# Sheringham Shoal and Dudgeon Offshore Wind Farm Extension Projects

Apportioning and HRA Updates Technical Note  
(Revision E) (Tracked)

Document Reference: 13.3.1

Title:  
Figure 3 Potential exclusion areas from SEP to avoid impacts to Greater Wash SPA Red-throated Diver populations

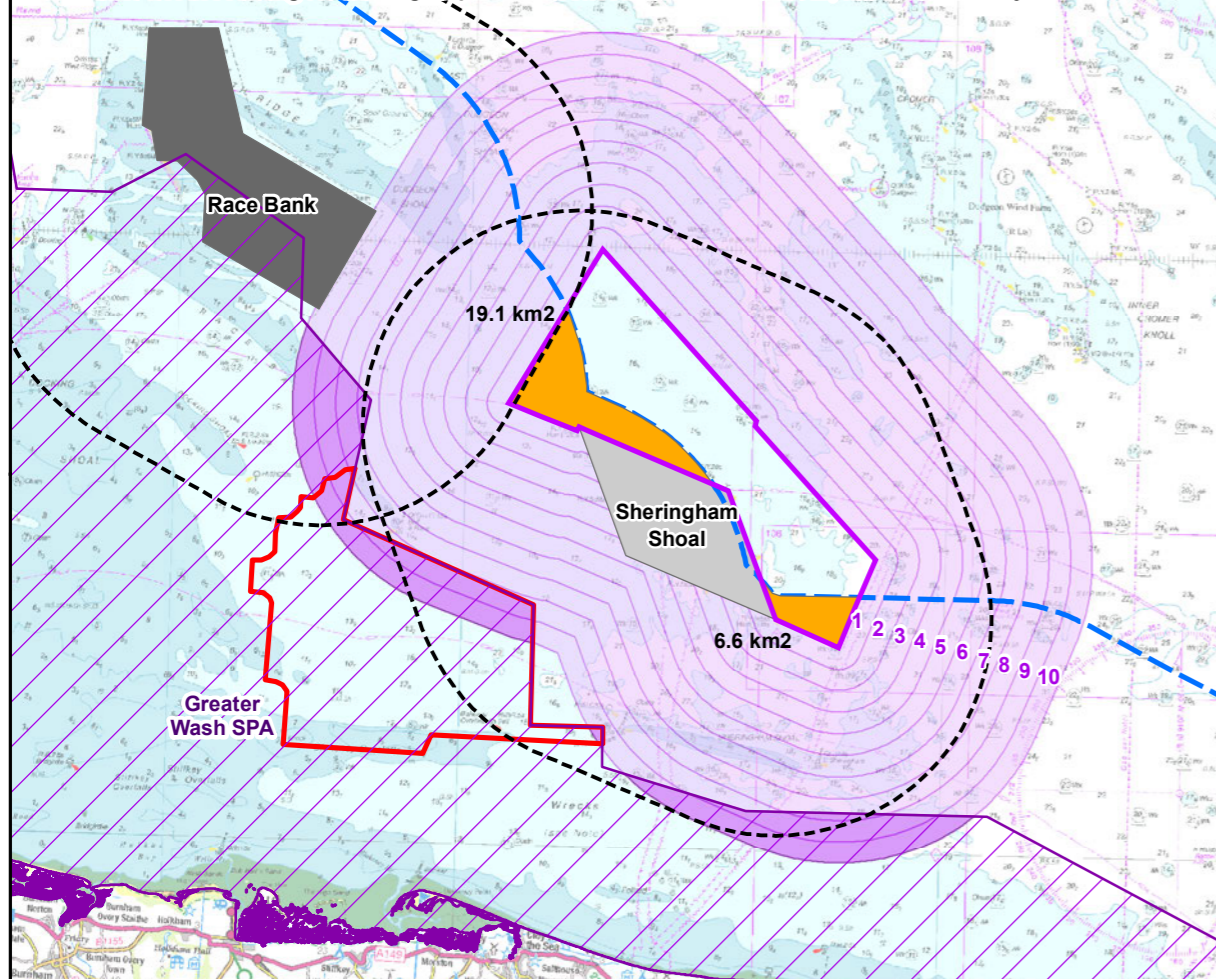
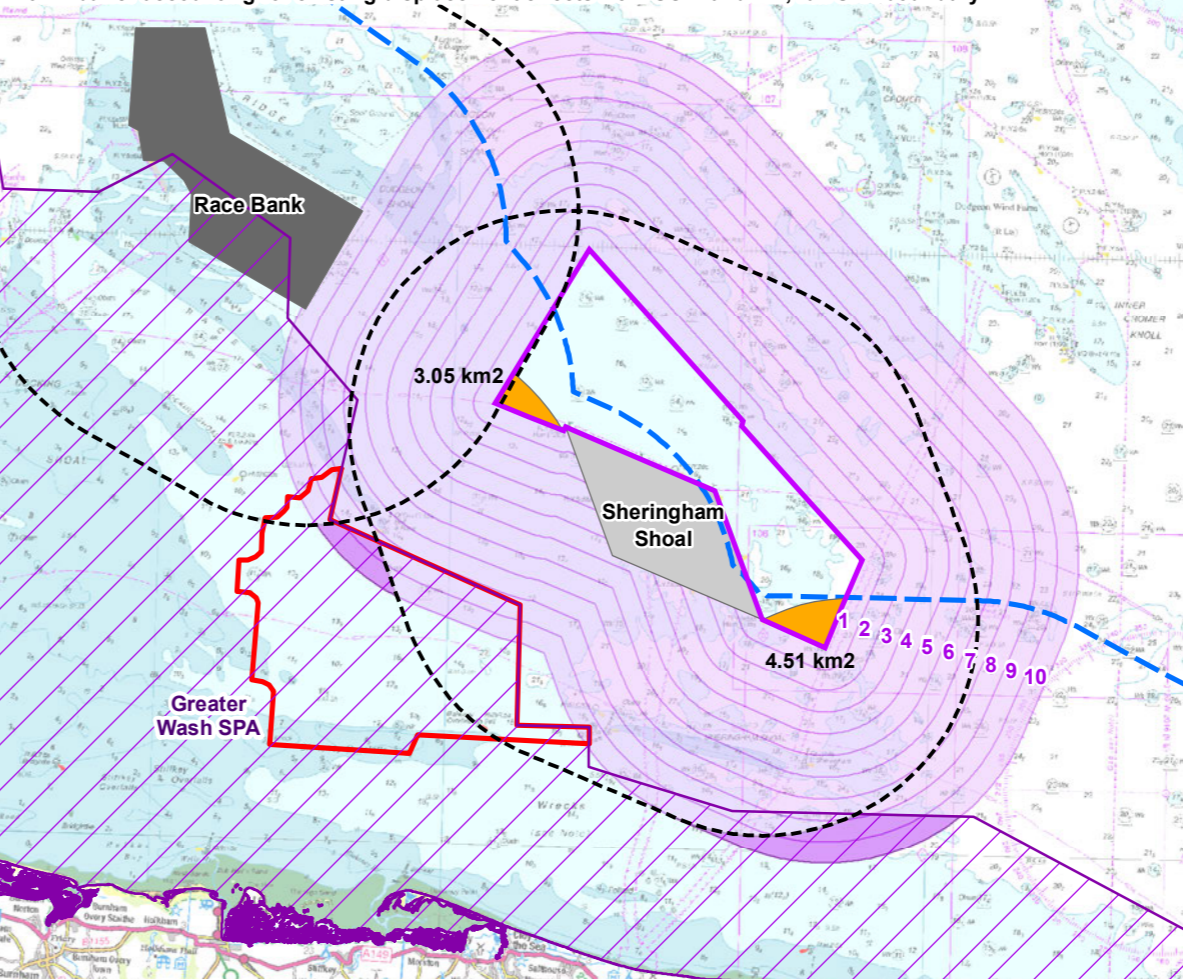
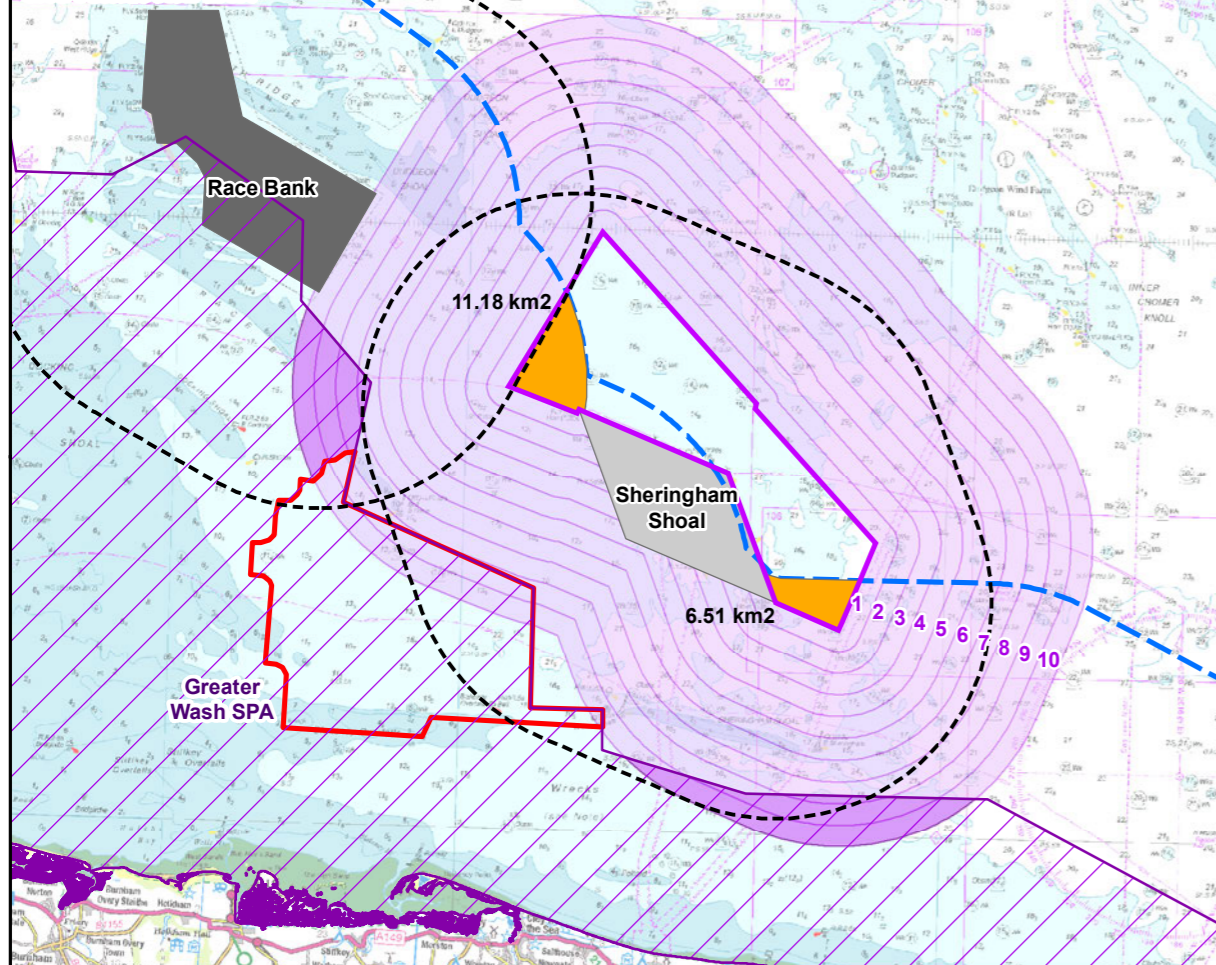
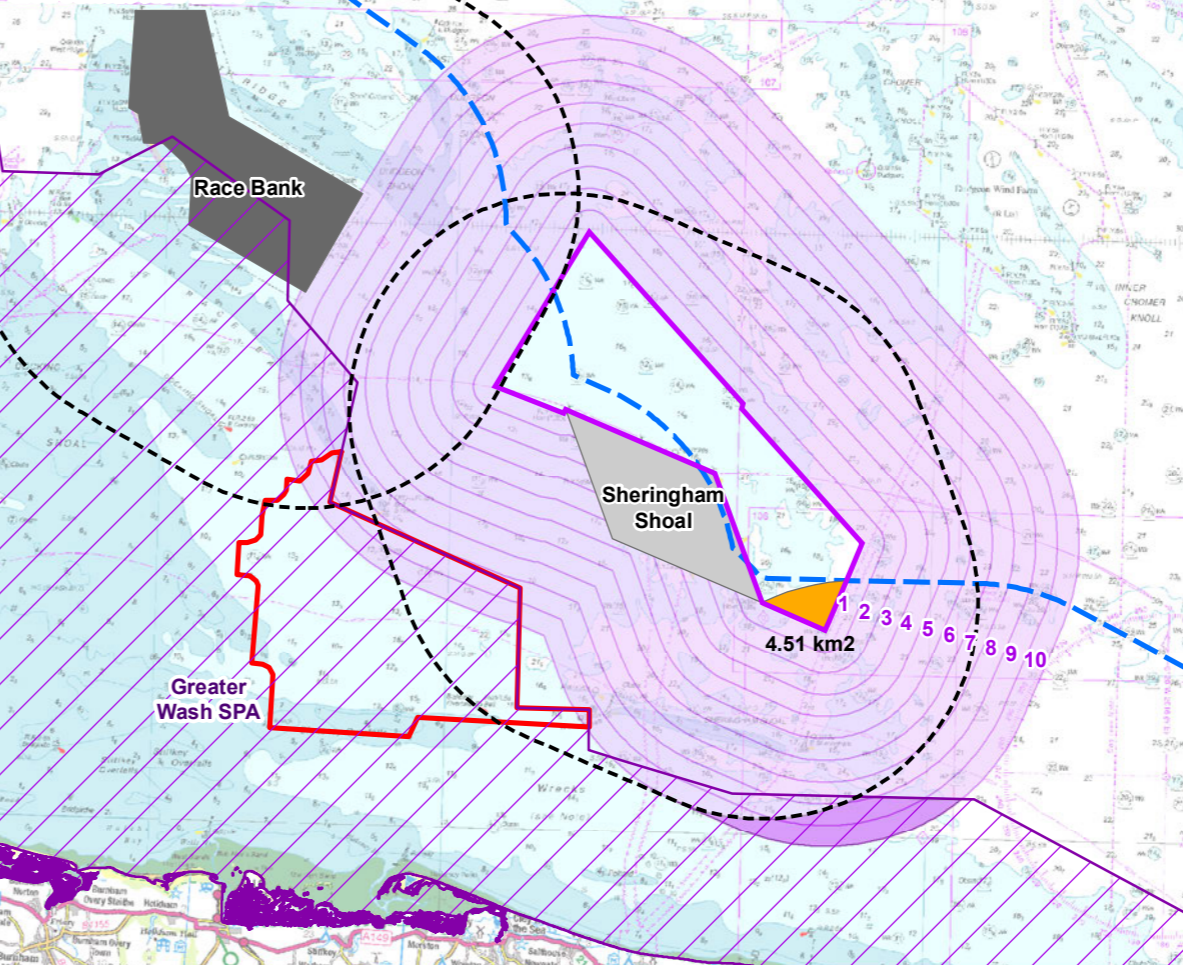
23	11. GW SPA RTD		<p>NE have some concerns over the validity of the method used to calculate the 'effective area' of displacement by scaling the area of effect proportionally according to the corresponding rate of displacement. This is because the proportion of the population that is displaced is not analogous to the area that birds are subject to displacement from. The logical supposition, if the area of effective displacement is say 55%, is that all of the divers remaining are using 45% of the area. However, this is not how displacement of Red throated diver is likely to operate, as the birds that are not displaced from a given area could well utilise it all. So, the area of effective displacement is always 100% for the birds that are displaced and could be 0% for the birds that are not displaced. In this case there seems no logical way to proportionally reduce the effective habitat loss. However, we do recognise the potential value in trying to account for the gradient of effect in spatial terms but in light of the relevant conservation objectives, consider that an area subject to any displacement effect is to</p>	<p>Noted. The Applicant maintains that it is reasonable to use the displacement gradient as a proxy to understand the 'effective area' of displacement. If this approach is not applied (or in the absence of an alternative approach proposed by Natural England), this suggests that the effect is the same, irrespective of the distance from the wind farm. This is not logical and will result in an unrealistic and wholly over-precautionary outcome. However, as Natural England notes, the presented information includes both the total area and effective area calculations.</p>

ID	Section of draft document	Paragraph	Natural England comment	Applicant response
			<p>some extent compromised in its ability to support red-throated diver across the whole of that area.</p> <p>We therefore welcome the presentation of figures for all approaches to calculating the area over which red-throated divers are subjected to displacement.</p>	
24	11. GW SPA RTD	101	<p>Natural England considers that, depending on the approach taken to calculating the area impacted, somewhere in the range of 20.63% to 42.01% of the Greater Wash SPA is subject to displacement impacts due to SEP in combination with existing OWFs. In light of the conservation objectives for the Greater Wash SPA, Natural England consider that, whilst SADEP's contribution to these impacts is minimal, AEOI on the red-throated diver feature at the Greater Wash SPA cannot be ruled out due to in combination displacement causing a significant reduction in the functional extent of the SPA available, which will modify the distribution of birds within those sites.</p>	<p>The Applicant reiterates the negligible contribution that SEP would make to these totals, as set out in <b>Table 14-7</b>. For the total SPA overlap area, this represents a difference of 0.49% (i.e. 41.52% excluding SEP, and 42.01% including SEP), and for effective area of displacement, a difference of 0.15% (20.48% excluding SEP, and 20.63% including SEP). It is not considered that this contribution would be distinguishable against natural variation, and supports the Applicant's position that SEP would not contribute to the in-combination effect.</p>

~~123.~~124. Figure 3, which all result in a reduction of the total area of GW SPA impacted; the areas where an effect would be avoided are shown shaded dark pink on

~~126.~~127. Figure 3. For Approach 1, the impacted area is reduced to zero, but for other approaches the impacted area is reduced from 1.77% (i.e. that calculated using the full SEP wind farm site boundary) to between 0.69% (Approach 3) and 1.36% (Approach 4); the effective area of displacement would be reduced from 0.56% to between 0.23% (Approach 3) and 0.44% (Approach 4).

~~127.~~128. The Applicant considers that Approaches 1-3 do not present justifiable mitigation options given that these do not take into account the existing effect of SOW and Race Bank OWFs and/or the presence of the red-throated diver MCA. **Table 14-5** also sets out the effective impacted area, taking into account areas

129. As noted in Section 1, following discussions with Natural England on 14 July 2023, the Applicant has committed to implementing Approach 2, as set out in Paragraph 119, top right of Figure 3, and in Table 14-5. This excludes areas of SEP that are located within 10km of GW SPA, where these parts of the SPA are not currently within 10km of the existing SOW and Race Bank OWFs. Under this approach, the total area of the SPA within 10km of SEP would be 43.41km<sup>2</sup>, or 1.23% of the SPA. However, taking into account areas within 10km of SOW and Race Bank, the total area effectively reduces to zero (Table 14-5).
